# HOWARD COUNTY HISTORIC PRESERVATION COMMISSION

## Agenda

Thursday, March 5, 2020; 7:00 p.m.

This Agenda identifies the work proposed and includes comments and recommendations from DPZ Staff. The recommendations included here do not constitute a decision of the Commission.

Figure 8 - Tree A on the left; 35.67-inch diameter. Tree B on the right; 40.13-inch diameter

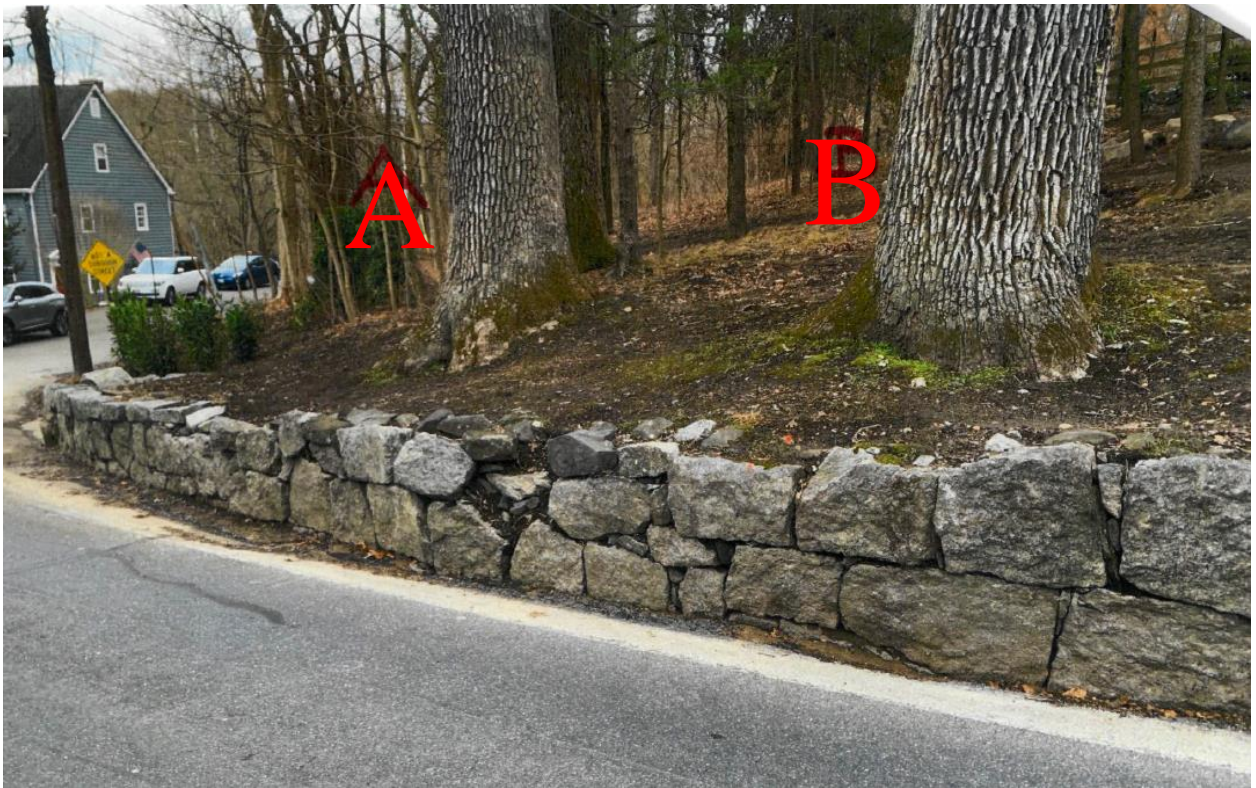
As mentioned above in the background, the proposed trees to be removed are most likely associated with the original Hazelhurst estate and historic house, Hazeldene/Lilburn (HO-353). The oak trees appear to be purposely planted along College Avenue, as an allée along the entry to the Hazelhurst house (HO-353). There are other oaks of a similar size along the roadway.

The trees appear to be in good health; there has been no evidence presented that indicates otherwise.

The application does not indicate if there is a plan to plant new trees and shrubs. While this area is adjacent to wooded side yard, a site visit in July 2019 (HPC-19-36) to review trees to be removed, revealed at least a dozen or more dead trees. In 2019, HPC-19-36 was approved to remove four trees in this vicinity. There were two additional trees to be removed at this time that did not require approval. The removal of the current trees, in addition to the six removed last summer, and the existing dead trees, will result in a change of character if there is no replanting plan.

**Staff Recommendation to the HPC:** Staff recommends the HPC determine if the application complies with the Guidelines and approve or deny accordingly. If the Commission approves the removal of the trees and relocation of the remainder of the wall, Staff recommends the HPC consider a replanting plan to mitigate the effect of those alterations.

Figure 10 -- Red lines indicates wall that was already re-aligned and rebuilt (for retroactive approval). Blue dashed line shows remainder to be completed (requires approval).

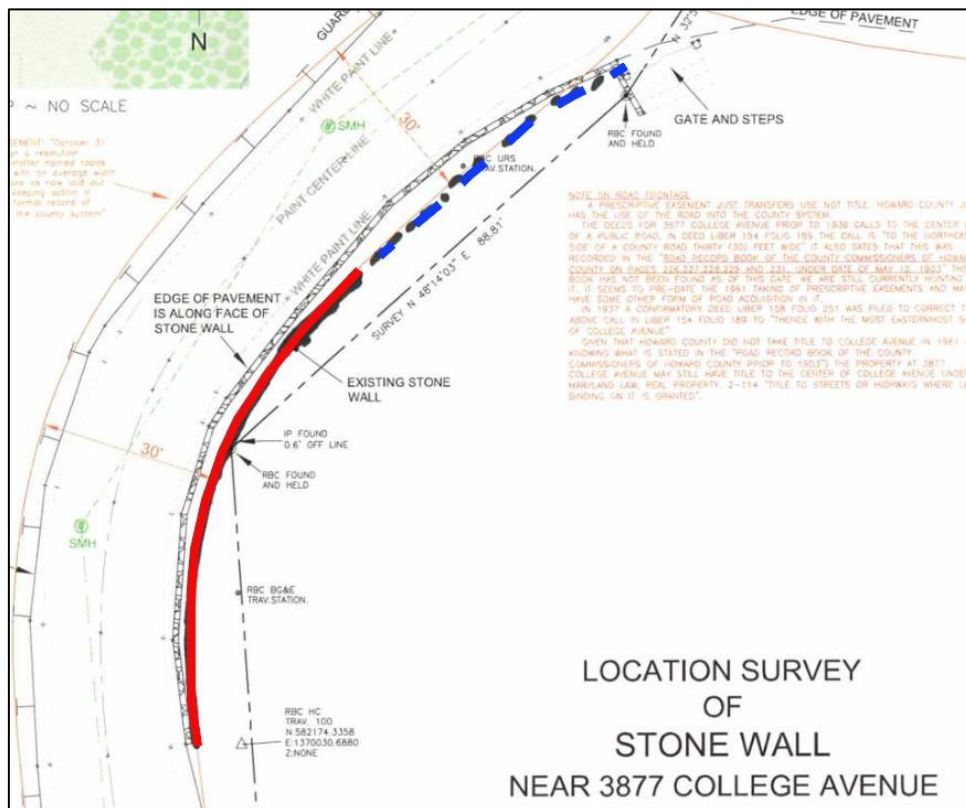
**Scope of Work:** The applicant seeks retroactive approval for the re-alignment of approximately 80 linear feet of stone wall that has been moved back between one and six feet from the roadway. The applicant also seeks approval to finish moving the remainder of the stone wall, which consists of approximately 65 linear feet that would be moved back four feet and gradually taper to a zero-foot setback at Ross Road. The applicant seeks approval to remove two oak trees in order to complete this work. The application states that the tree root zone area would be impacted by the wall relocation, which would cut through the root zone in order to pull the wall back four feet at this location. Tree A, shown in Figure 8, has a circumference of 112 inches, with a diameter of 35.67 inches. Tree B, shown in Figure 8, has a circumference of 126 inches, with a diameter of 40.13 inches.

The relocation and rebuilding of the wall was done without approval and is not eligible for tax credits.

Figure 22: Drawing of proposed column with artwork and addresses

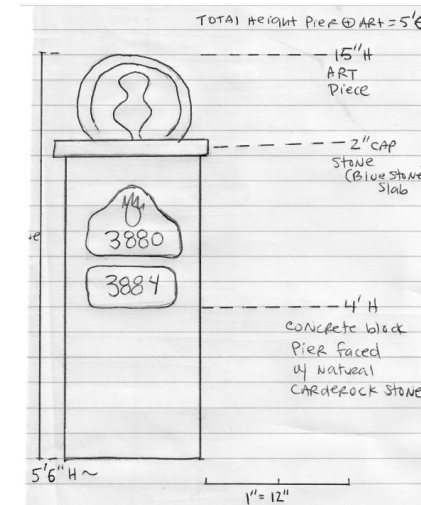
- 2) **Address Plaques** - Install two black aluminum address plaques on the front of the pier. The upper plaque will be approximately 16 inches wide by 11 inches high and will read "Welcome" and have the image of a pineapple below. Underneath the pineapple, will be the main house number "3880". The second plaque will be 15.75 inches wide and 6 inches high and read

“3884”, the address of the barn. All lettering will be gold and raised. A 12-inch-wide hardscape lighting strip will be installed under the capstone to illuminate the address at night. Refer to Figure 22.

- 3) **Custom Art Work** - Install a custom made 15-inch-high art piece on top of the bluestone cap to reference the historic site’s industrial heritage. The art piece will consist of a round, antique grinding stone, set into the bluestone cap. A toothed metal gear (non-rusting, brown in color), referencing the gears used in local water powered mills will be attached. A black powdered coated metal sculpture that is designed based on a historic door latch from the house, will be installed and subtly backlit at night using a puck-shaped LED light. The electrical outlet on the pillar will be on the back side of the column, not visible from the public right-of-way.

**Address Plaques (Item 2)** - The address plaques will be a black metal with gold detailing, which is compatible with other address plaques on the building and nearby historic buildings.

**Custom Art (Item 3)** - The use of the millstone as a piece of art is compatible with the historic building, which was associated with the historic Burgess Mill. Prior to the 2018 flood, a local historic millstone was located in a park at the corner of Main Street and Ellicott Mills Drive.

**Staff Recommendation to the HPC:** Staff recommends the HPC approve: Item 1 (Stone Pillar), Item 2 (Address Plaques), Item 3 (Custom Art), Item 4a (Driveway Path Lights), Item 5 (Driveway Freestanding Pole Light), Item 6 (Kitchen Porch Step Lights).

Figure 32: Location of proposed in-ground pool and other site alterations. The four chairs show the approximate corners of the pool. Items 1-4

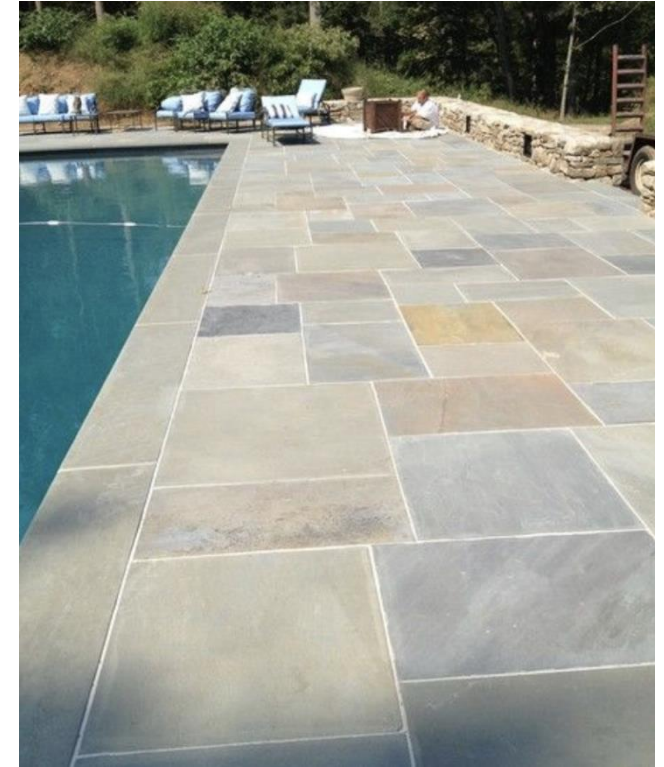
- 1) **Pool** – Construct an 18-foot wide by 36-foot long in-ground swimming pool in the backyard. Refer to Figure 32.
- 2) **Coping** – Install bluestone coping around pool.

The remaining items to be reviewed will be the most altering to the rear of the property. The existing rear yard directly behind the house is relatively flat and increases in grade significantly to the west and then decreases significantly in grade to the east beyond the property line. As shown in the landscape and site plan, the majority of the rear yard will be disturbed with some type of alteration. Aside from new landscaping trees and shrubs, the applicant proposes to construct a 6-foot berm with boulders and a slide, three new structures, and a set of double retaining walls. While each item will be addressed below, it is important to note that it is the comprehensive plan that results in a change of character to the property, even though one item might be fine and comply with the Guidelines on its own. The application generally complies with the Guidelines and Secretary of the Interior Standards since the alterations are to the rear of the property and are not connected to the historic house. However, the

alterations do change the character of the property by altering the site and spatial relationships. When possible, a reduction in proposed site features would assist the application in better complying with the Guidelines and Standards.
